City of Rockport

CITY COUNCIL REGULAR MEETING AGENDA

18. Consider the approval of Construction Change Directive #4 related to the new City Hall project

Consider the approval of Construction Change Directive #5 with Teal Construction related to the new City Hall project (cost pending)

FILE: C:\Users\Architect\Documents\100% CD_AE-ROCKPORT CITY HALL_22_spatrickECOHA.rvt
DATE: 8/9/2024 12:40:46 PM
DATE STAMP: 8/9/2024 12:40:46 PM

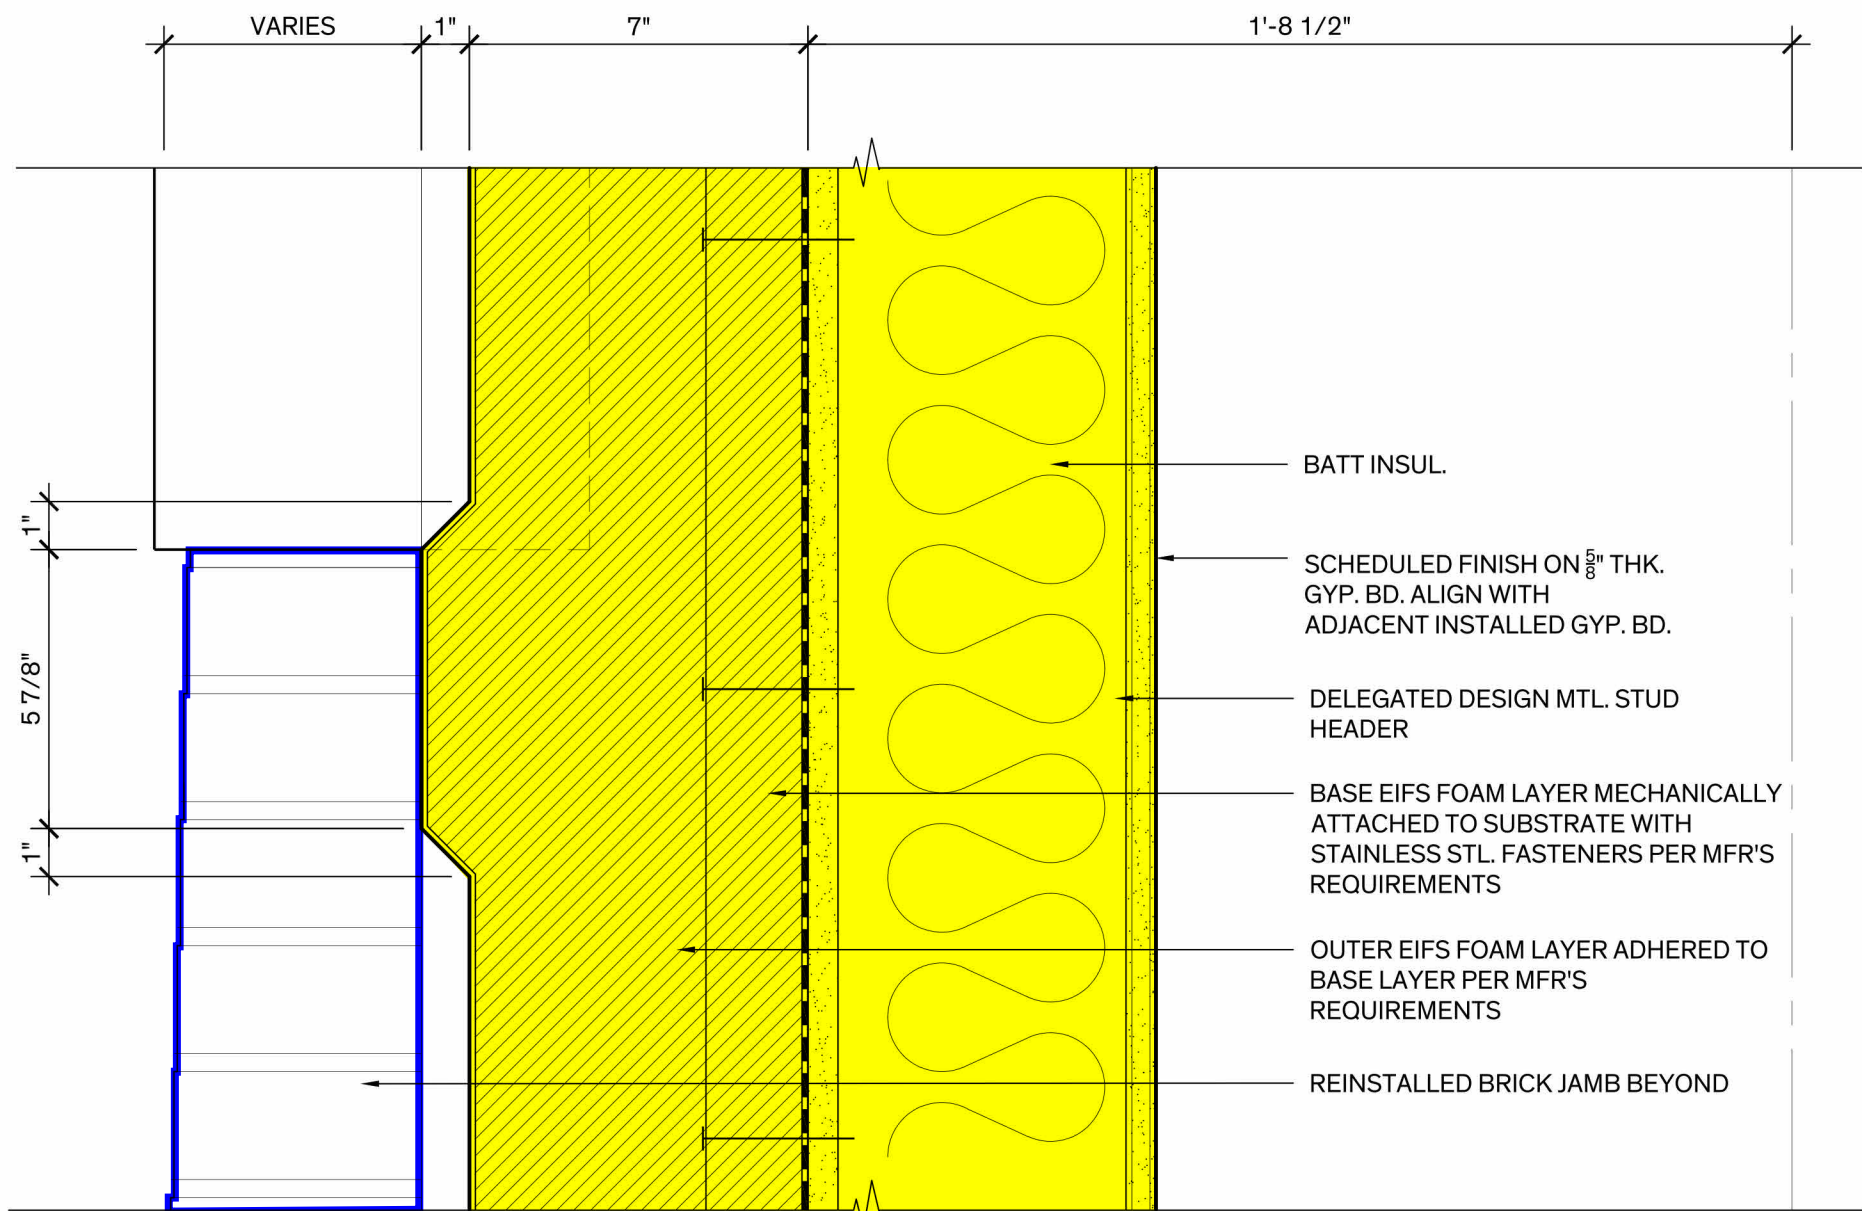
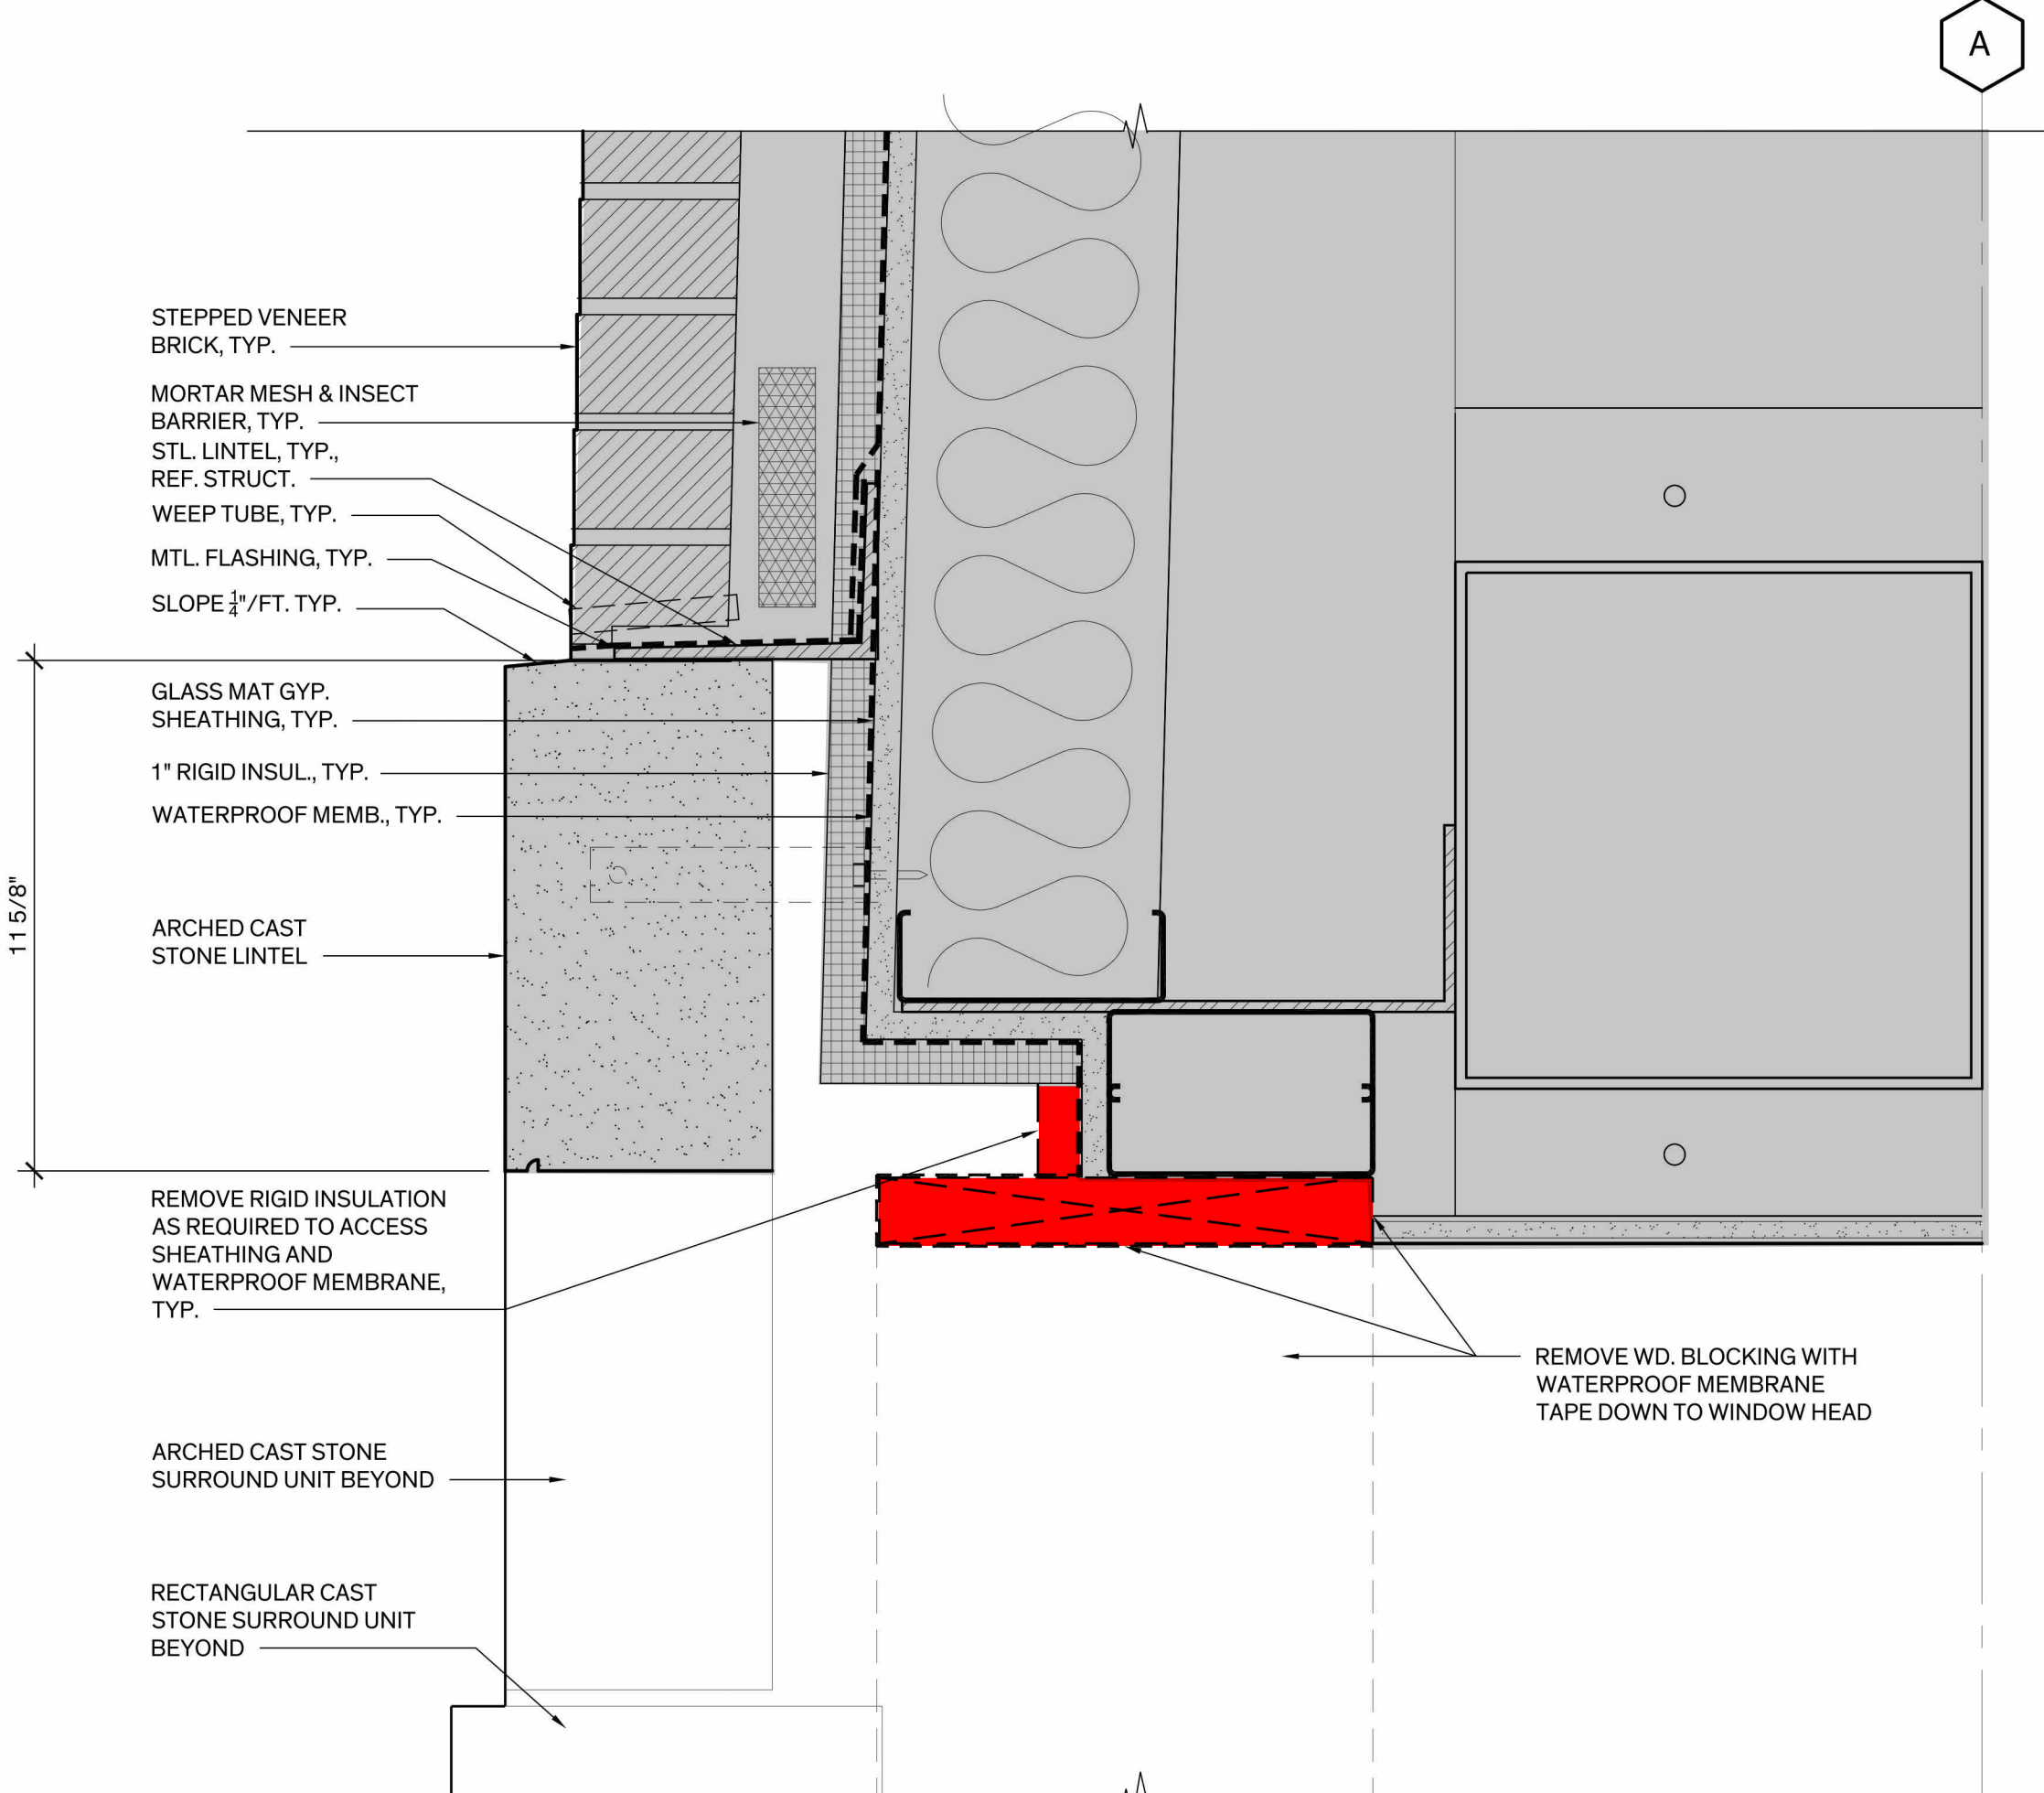
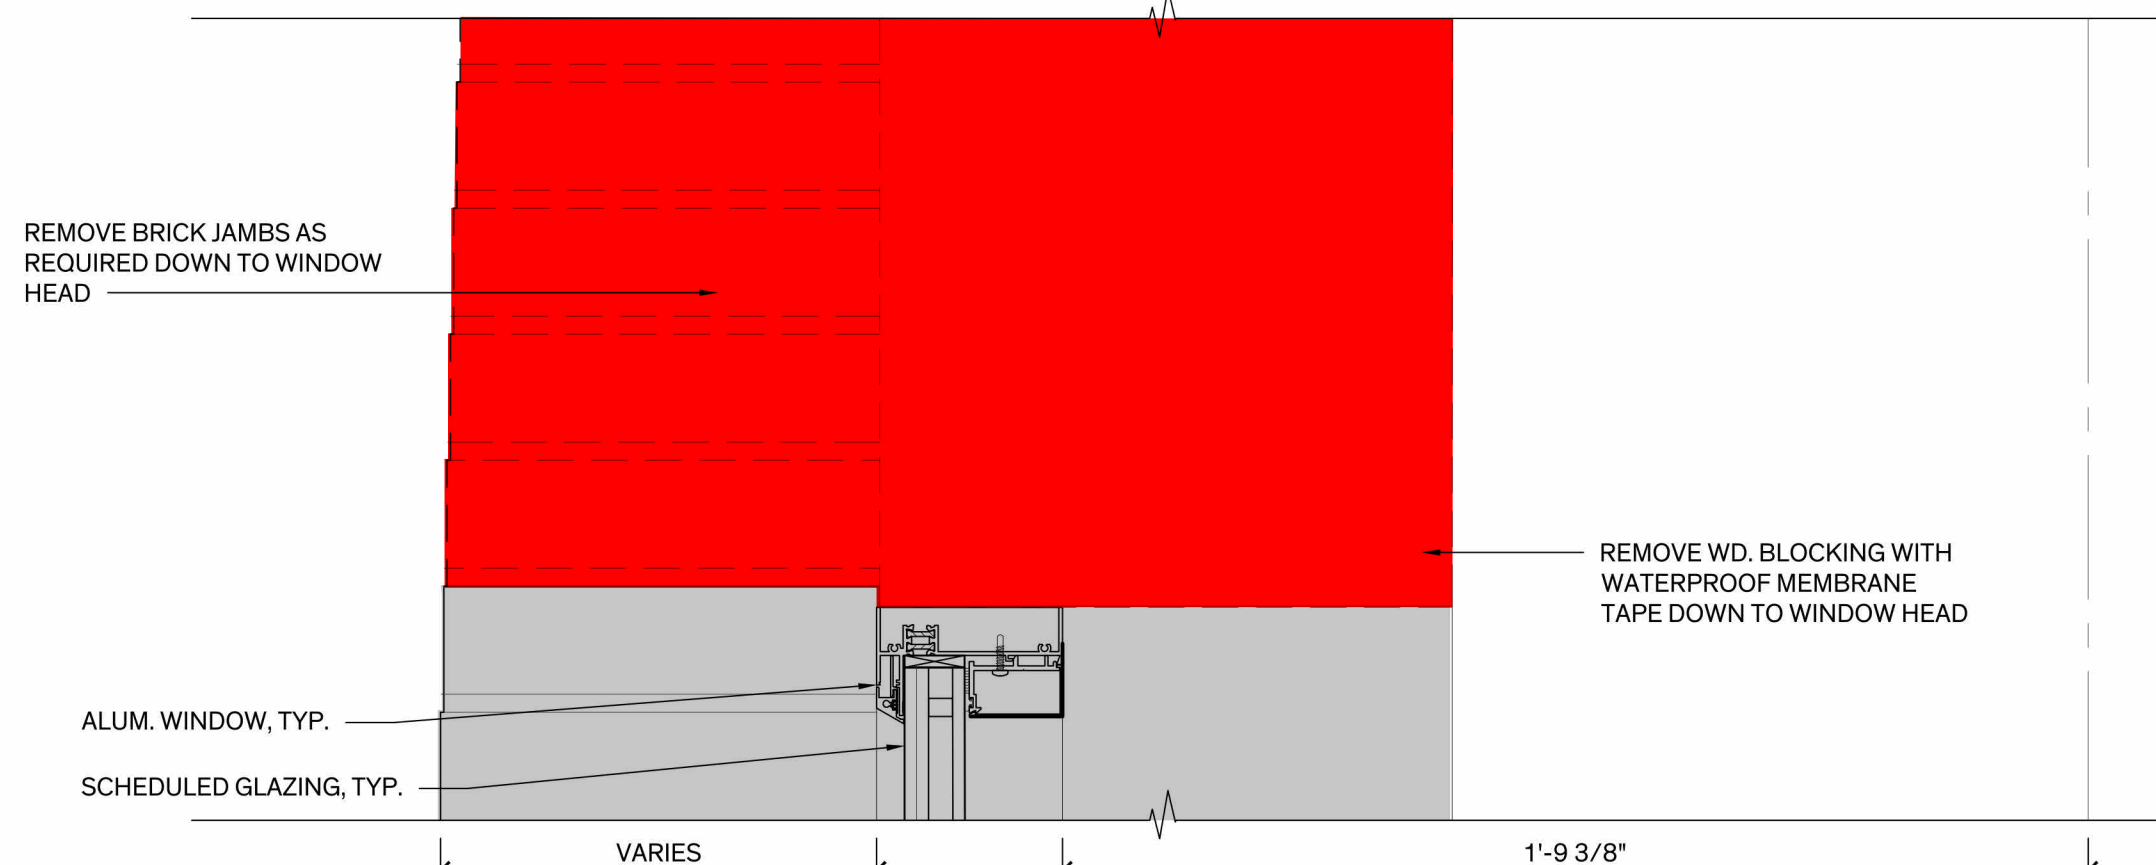
Special infill/reworking of as-built conditions is now required for areas that should have been incorporated with the surrounding metal framed walls per direction provided well in advance of metal framing installation. Had these changes been properly coordinated by the General Contractor, the change in material and labor would have been negligible, especially given the elimination of arched framed openings, etc. Teal is therefore responsible for all metal framing costs associated with this change request.

-The change from full height arched to reduced height rectangular windows with metal framed wall and decorative panels above was made during window shop drawing review dated 11/22/22. Teal did not coordinate the change with other affected subcontractors.

-The area was further documented in RFI 82 dated 2/7/23, see SK-3A through 3D.

-Architexas noted the missing framing and window head for the rectangular window openings in metal framing shop drawing review dated 2/22/23.

-Construction of metal framing and window openings proceeded in conflict with design team direction. Architexas noted the incorrectly built window framing in Field Report 12 from site visit on 1/3/24 and referred back to RFI 82.

-Teal continued construction of the tower exterior envelope and window openings with incorrect conditions and did not issue RFI 168 until 7/16/24.

-Teal did not coordinate the infill panels designed for the area above the rectangular windows (SK-1 provided 11/22/22 with window shop drawing review) and sequencing of surrounding construction. Infill panels needed to be coordinated prior to proceeding with waterproofing and finished masonry openings. Teal is responsible for all masonry removal and reinstallation required in this change request.

Provide EIFS infill with recessed panel detailing within arched openings above tower windows. Refer to attached revised SK-3A, SK-3B, SK-3C, SK-3D, and new SK-3E.

REMOVE
AS-BUILT TO REMAIN
INFILL REQUIRED AT EIFS PANELS
REINSTALL REMOVED COMPONENTS
